ATTACHMENT A

KENWOOD COMMUNITY & SENIOR CENTER ATTACHEMENT A

ADDENDUM #1 – REVISED DRAWINGS

S3.12

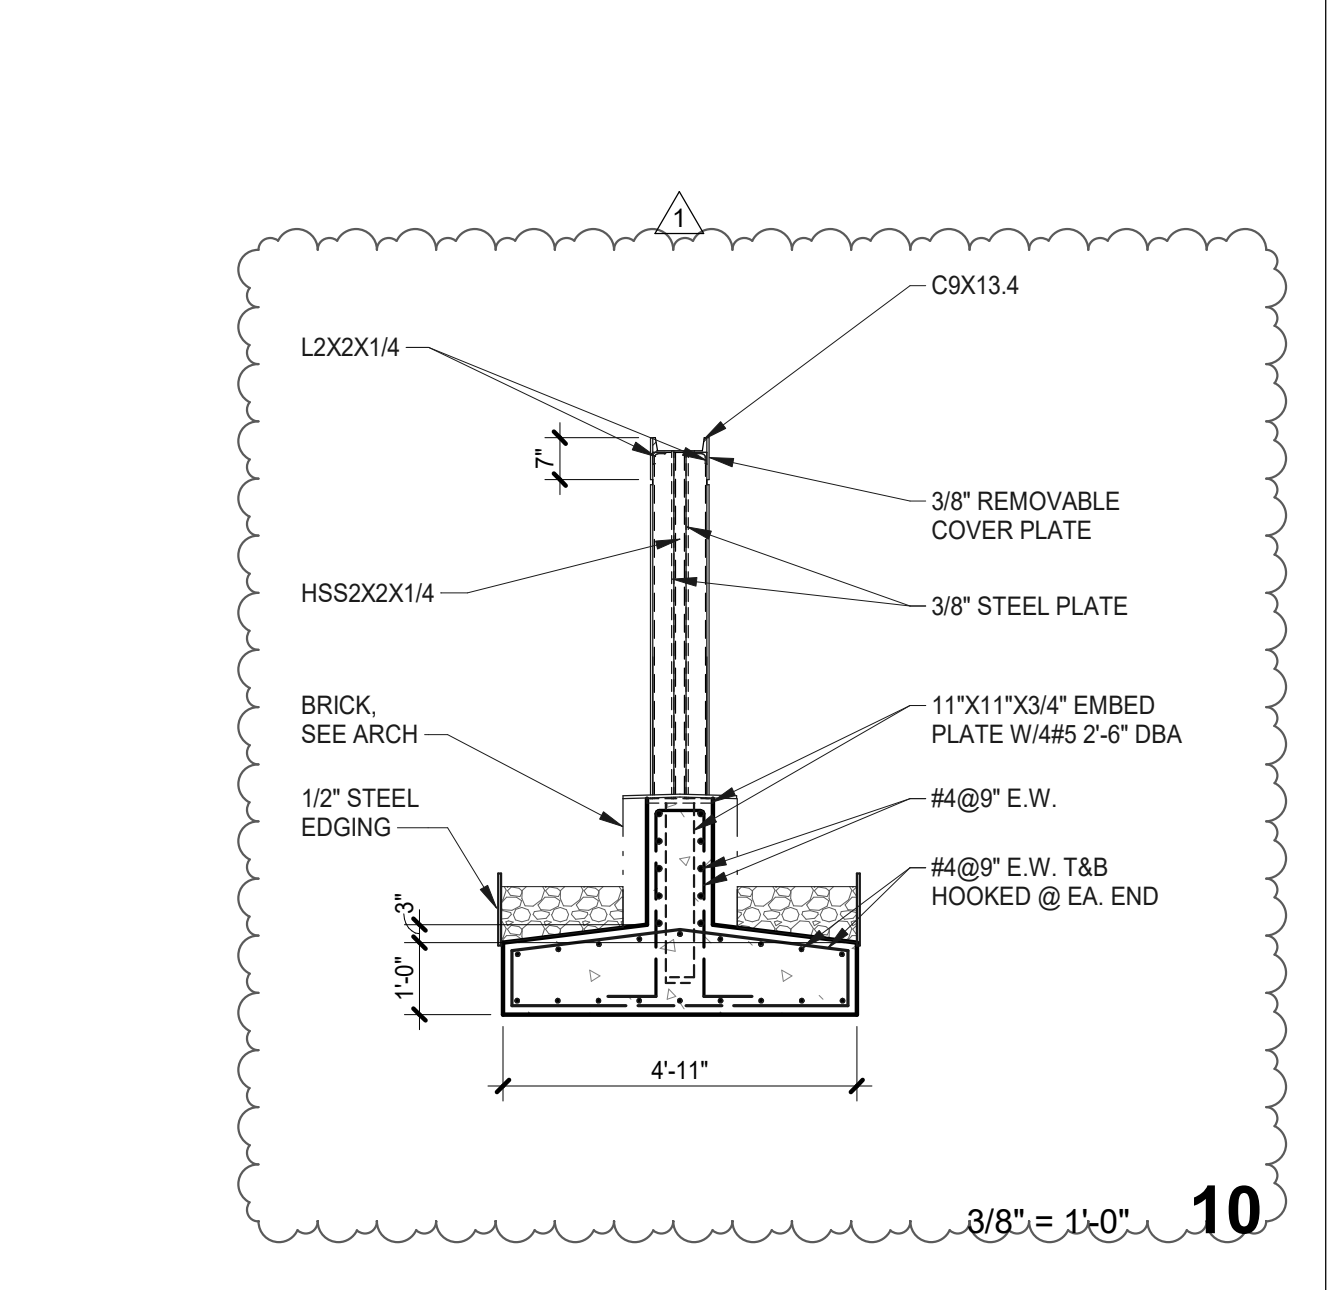
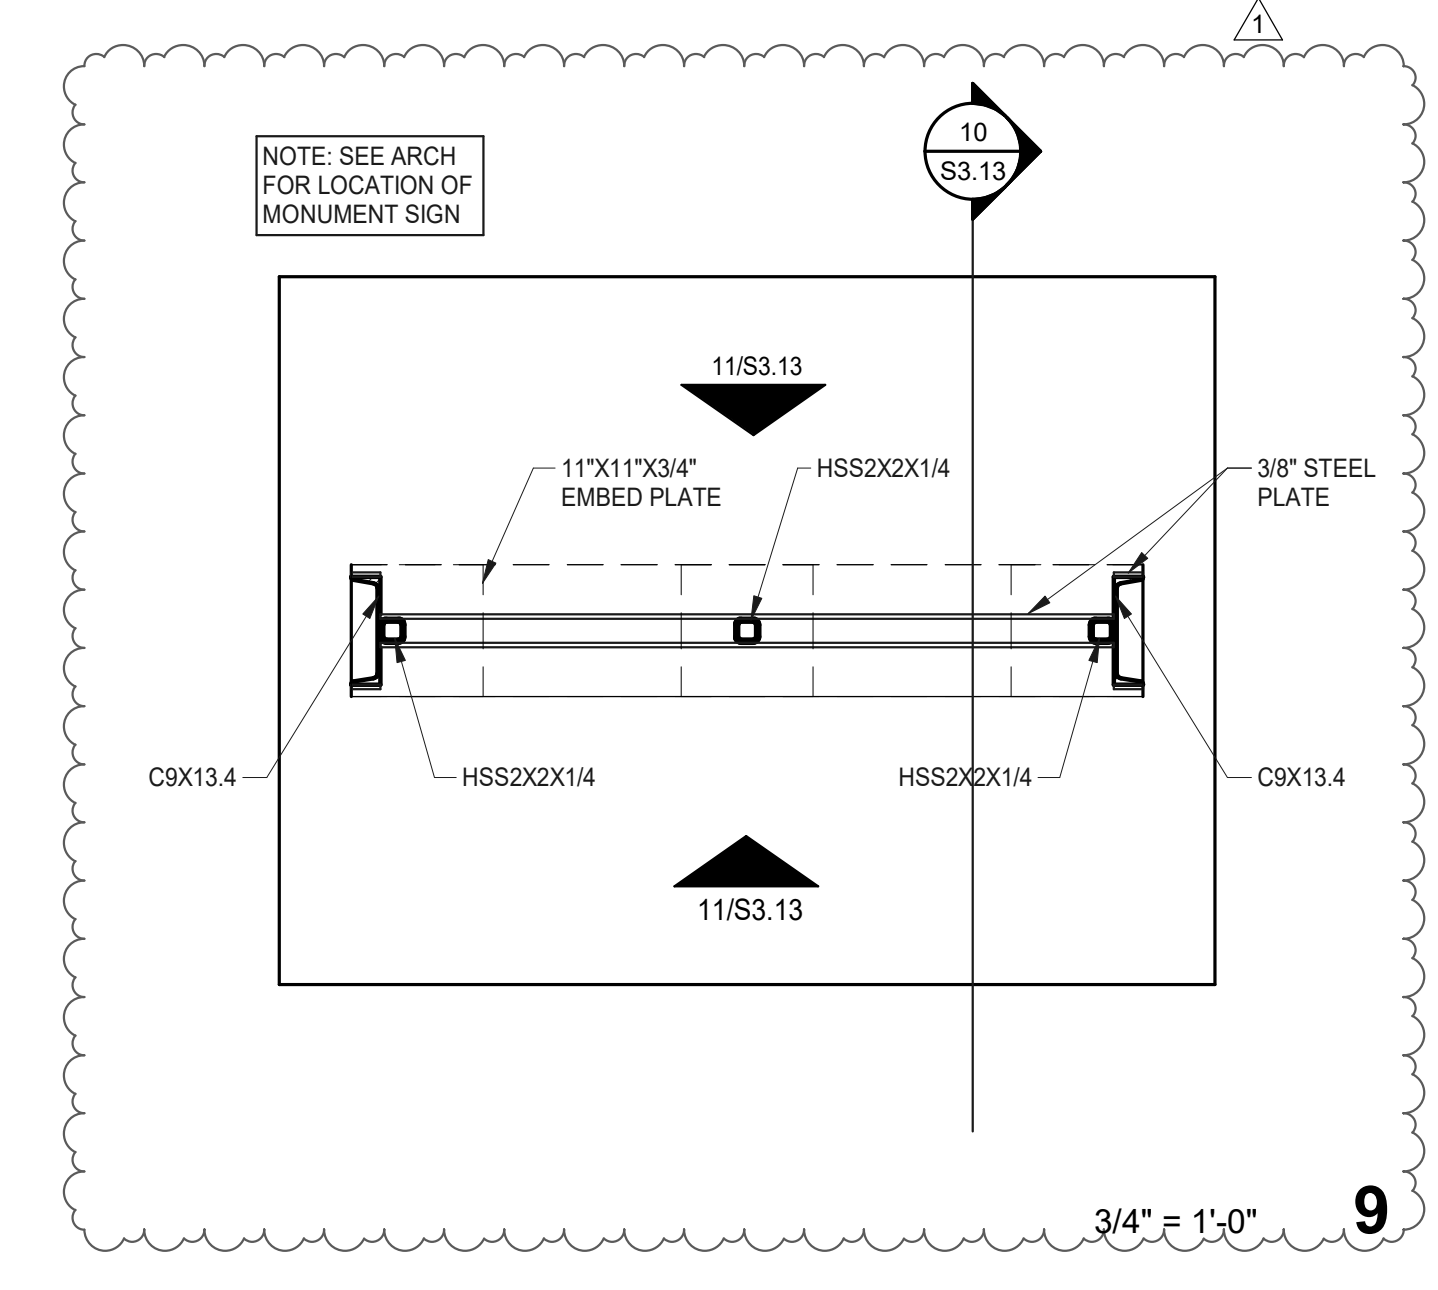
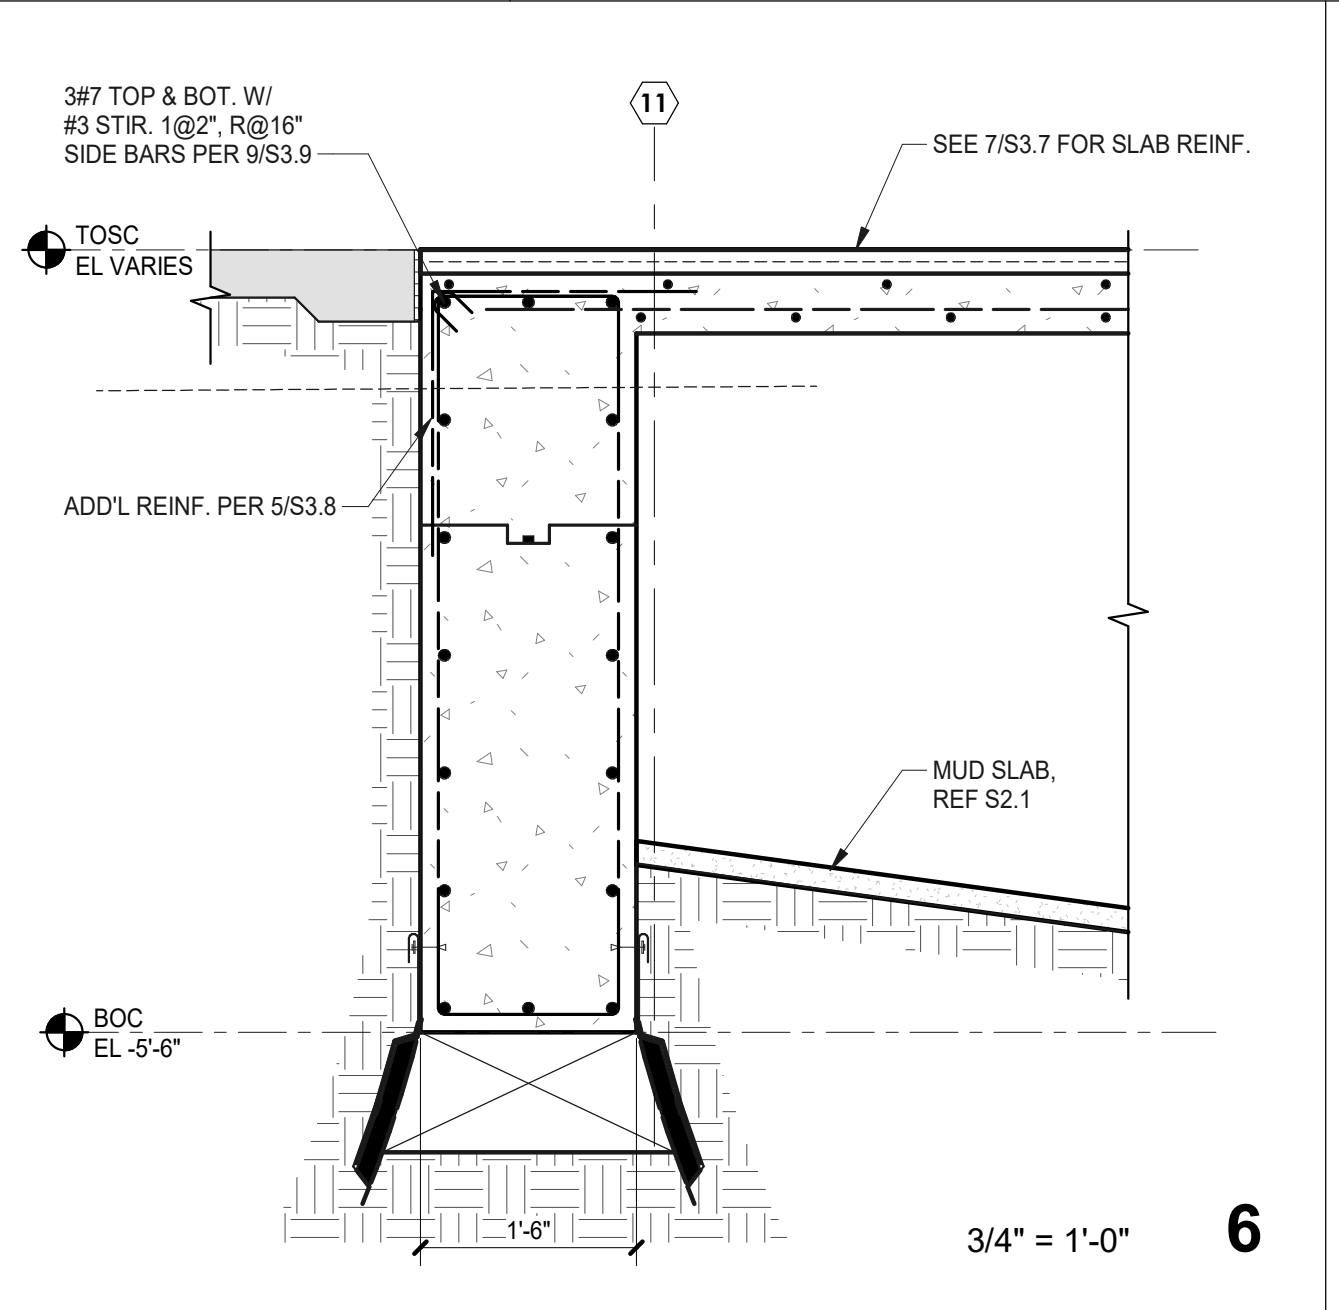
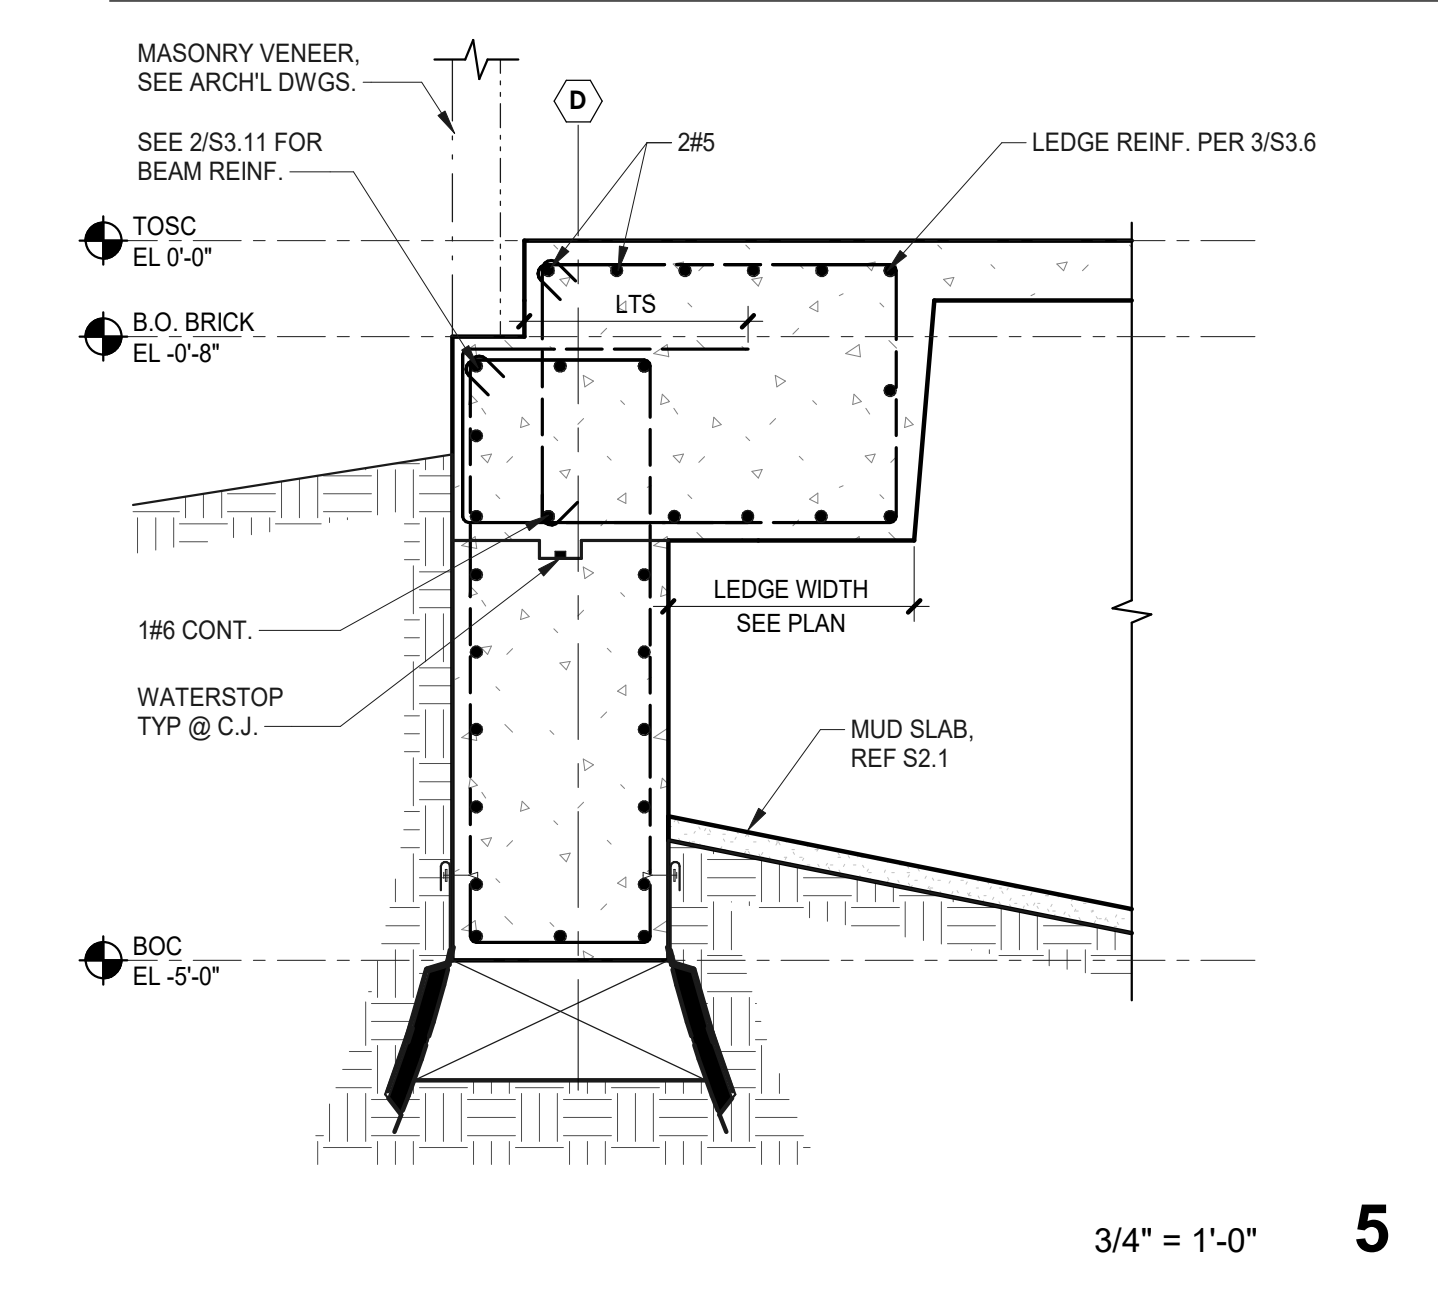
The roughened concrete has been replaced with a bond breaker to improve crack control, refer to attached revised sheet S3.11 & S3.12
